UNITED STATES PATENT AND TRADEMARK OFFICE

APPLICATION NO.	FILING DATE	FIRST NAMED INVENTOR	ATTORNEY DOCKET NO.	CONFIRMATION NO.
10/737,345	12/16/2003	Andrew Niemczyk	1504-P3005.001	6020

Office Action Summary	Application No. 10/737,345	Applicant(s) NIEMCZYK, ANDREW	
	Examiner William V. Gilbert	Art Unit 3635

DETAILED ACTION

Figure 2 from Rose

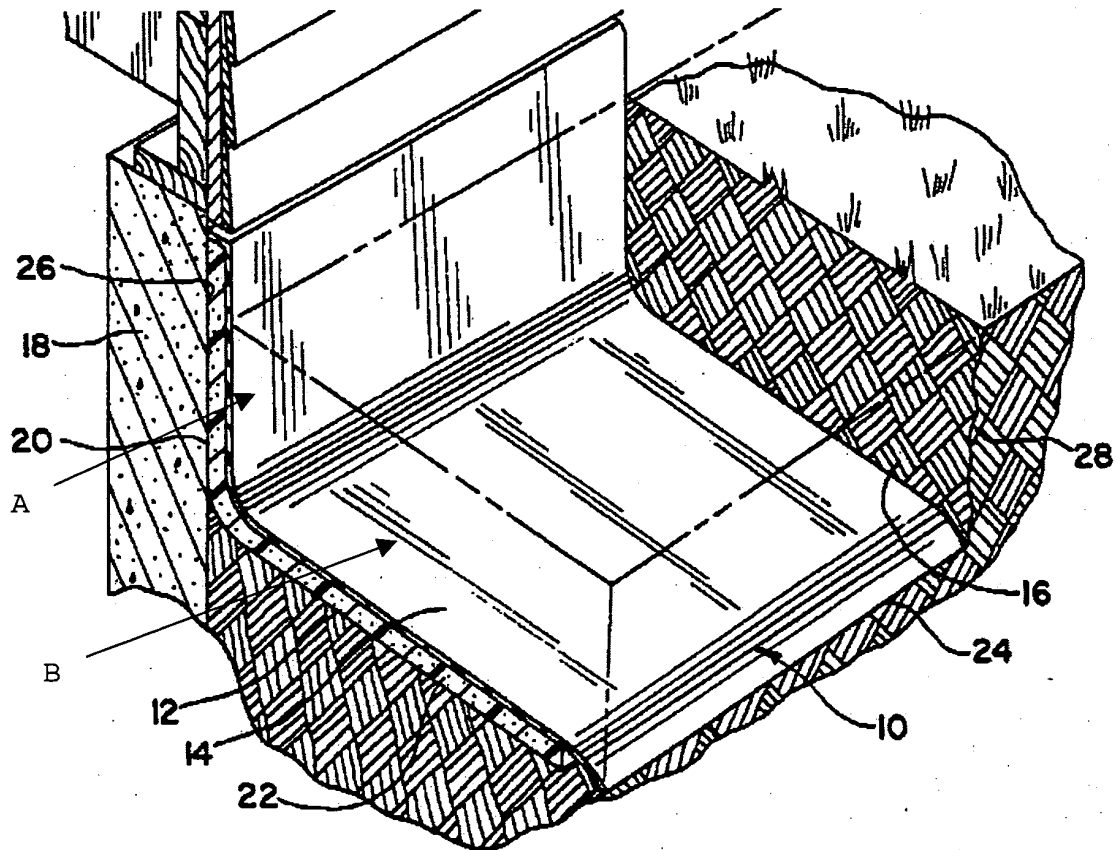
digging ground to form a trench (on the exterior side of the basement wall) with the trench wide enough to receive a semi-flexible member (Column 7, lines 52-60; See Figure 2), placing overlapping water impermeable semi-flexible members (Figure 5, elements 10a, 10b, 10c, 10d; Column 4, lines 29-32) in the trench with a short leg (see element "A" from attached Figure 2 from Rose below) of each member (abutting against the basement wall) and having a long leg (see element "B" from attached Figure 2 from Rose below) extending substantially away from the basement wall (See Figure 2, generally; see Column 8, lines 9-20), and backfilling the trench with soil above the water impermeable members (Column 8, lines 35, 36).

Regarding Claims 1 and 4, Rose discloses a basement wall water protection system (14) comprising at least one (or a plurality of, per Claim 4) water impermeable flexible member(s) (Column 2, lines 44-46; Column 4, line 43; Figure 5), having a short leg section (see "A" from attached Rose Figure 2 above) and a long leg section (see "B" from attached Rose Figure 2 above) extending away from the basement wall (see Figure 2, generally; see **Claim Rejections - 35 USC § 112** above regarding the statement about the "basement wall"), a first side edge (14a, per Claim 4) and a second side edge (14b, per Claim 4) that can join each other to form a watertight joint (Column 6, lines 49-52, per Claim 4). While Rose discloses the dimensions of the waterproof member to be approximately 4'6" by 8'6" (Column 4, lines 60-63), Rose does not disclose the long leg section extending at a calculated distance at least as great as the tangent of 15 degrees times the height of the basement wall below the impermeable flexible member (see **Claim Rejections - 35 USC § 112** above regarding the statement about the "basement wall"). It would have been obvious at the time the invention was made to a person having ordinary skill in the art to make the dimension of the long leg in Rose as calculated in the Claim because the Applicant's Specification (Page 7, paragraph 0031) states that the length of the long leg could be approximately

Regarding claim 5, Rose discloses a short leg (see "A" from attached Figure 2 from Rose, above). The phrase, "being placed below ground level and free to move against said basement wall and held against said wall solely by ground pressure" is a statement of intended use of the claimed invention and must result in a structural difference between the claimed invention and the prior art in order to patentably distinguish the claimed invention from the prior art. If the prior art structure is capable of performing the intended use, then it meets the claim.

Regarding Claim 9, Rose discloses the long leg (see "A" from attached Figure 2 from Rose, above) extending away from the basement wall at approximately a 5-degree downward slope (Column 5, lines 29-37; see Claim 11 rejection above for calculation). Regarding the phrase "extending at least approximately the height of the basement wall below the leg times the tangent of 15 degrees", see rejections of Claims 1 and 4, above; see **Claim Rejections - 35 USC § 112**).
